UNITED STATES PATENT AND TRADEMARK OFFICE

APPLICATION NO.	FILING DATE	FIRST NAMED INVENTOR	ATTORNEY DOCKET NO.	CONFIRMATION NO.
10/702,372	11/05/2003	Ming-Dou Ker	JC-7897-DIV	8473
23900	7590	02/02/2006	EXAMINER	
JC PATENTS, INC. 4 VENTURE, SUITE 250 IRVINE, CA 92618				STARK, JARRETT J
		ART UNIT		PAPER NUMBER
				2823

DETAILED ACTION

[11] Patent Number: 6,015,993

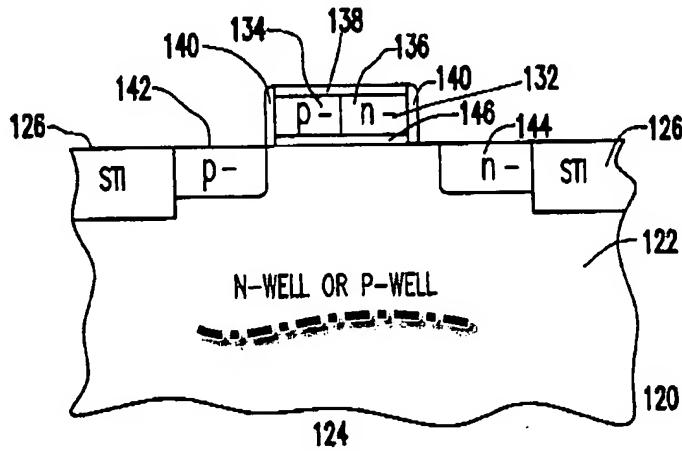
Regarding claims 39 & 46, the applicant argues that Voldman et al. does not disclose the well. The examiner points out to the applicant that Figs. 2,4, & 7 and the front page of US Patent 6,015,993 all show the well. Voldman et al. Col. 4, lines 20-25 states:

"a lateral unidirectional bipolar type insulated gate transistor is formed in an implanted well 152 in a surface semiconductor layer 154."

FIG.7

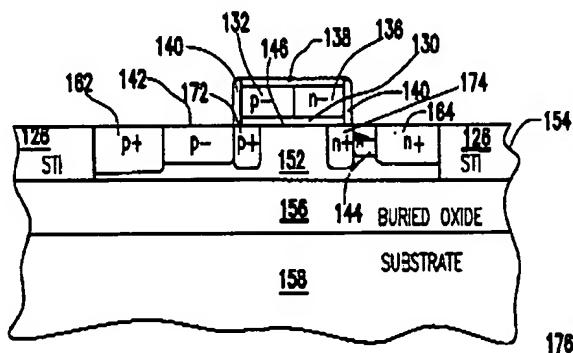
Claim 39 is rejected under 35 U.S.C. 102(b) as being anticipated by Voldman et al. (US 6,015,993).

Regarding claim 39, Voldman teaches a method of forming a non-gate diode of a SOI, comprising:

providing an SOI with a substrate (Voldman, Figs. 7), an insulating layer (Voldman, Figs. 7, element 156) and a silicon layer (Voldman, Figs. 7, element 154) sequentially stacked together,

forming a pair of isolating structures (Voldman, Fig. 7, elements 126) in the silicon layer, so as to define a well region (Voldman, Fig. 7, elements 152) there between;

forming a lightly doped region in the well region, the lightly doped region comprising two neighboring lightly doped P-type region and N-type regions; and forming a P-type heavily doped region and an N-type heavily doped region in the well region and wherein

the P-type heavily doped region (Fig. 7 [162]) is configured between and connects the lightly doped P-type region (Fig. 7 [142]) and one isolating structure (Fig. 7 [126]), and the N-type heave^{SP?} doped region (Fig. 7 [164]) is configured between and connects the lightly doped N-type (Fig. 7 [144]) and the other isolating structure (Fig. 7 [126]).

Regarding claim 40, Voldaman teaches the method according to claim 39, wherin the first type and second type doped regions are implanted with P-type and N-type ions, respectively (Voldaman, Fig. 7, elements 162 & 164).

Regarding claim 41, Voldaman teaches the method according to claim 39, wherein the well region is lightly implanted with a P-type ion (Voldaman, Fig. 7, elements 142).

Regarding claim 42, Voldaman teaches the method according to claim 39, wherein the well region is lightly implanted with an N-type ion (Voldaman, Fig. 7, elements 144).

FIG.7

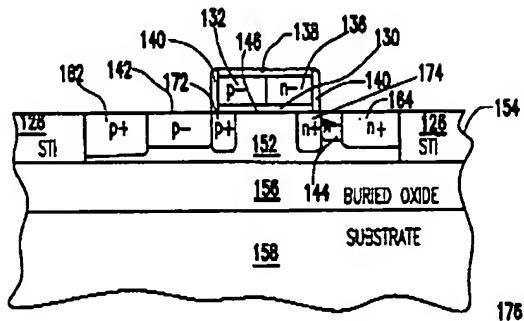
Regarding claim 46, Voldaman teaches a method of forming a non-gate diode in a CMOS process, comprising:

Providing a substrate (Voldaman, Fig. 7, elements 156) having a well region therein (Voldaman, Fig. 7, elements 152);

Forming a pair of blocking isolation structures in the substrate (Voldaman, Fig. 7, elements 126);

Forming a first type-doped region (Voldaman, Fig. 7, elements 162) located in the well region and between the blocking isolation structure, and

Forming a pair of second type doped regions (Voldaman, Fig. 7, elements 144 & 164) located in the well region and respectively adjacent to the blocking isolation structure (Voldaman, Fig. 7, elements 126), wherein each second type doped region is separated from the first type doped region by the well (Voldaman, Fig. 7, elements 152).

Regarding claim 47, Voldaman teaches the method according to claim 46, wherin the first type doped region and the second type doped region are implanted with P-type and N-type ions respectively (Voldaman, Fig. 7, elements 162 & 164).

Regarding claim 48, Voldaman teaches method according to claim 46, wherein the well region is lightly implanted with a P-type ion (Voldaman, Fig. 7, elements 142).

Regarding claim 49, Voldaman teaches method according to claim 46, wherein each second type doped region and the first type doped region defines a spacing, separating the second type doped region from the first type doped region (Voldaman, Fig. 7, elements 152).

Regarding claim 49, Voldaman teaches method according to claim 46, wherein the spacing is undoped. (Voldaman, Fig. 7, elements 152).
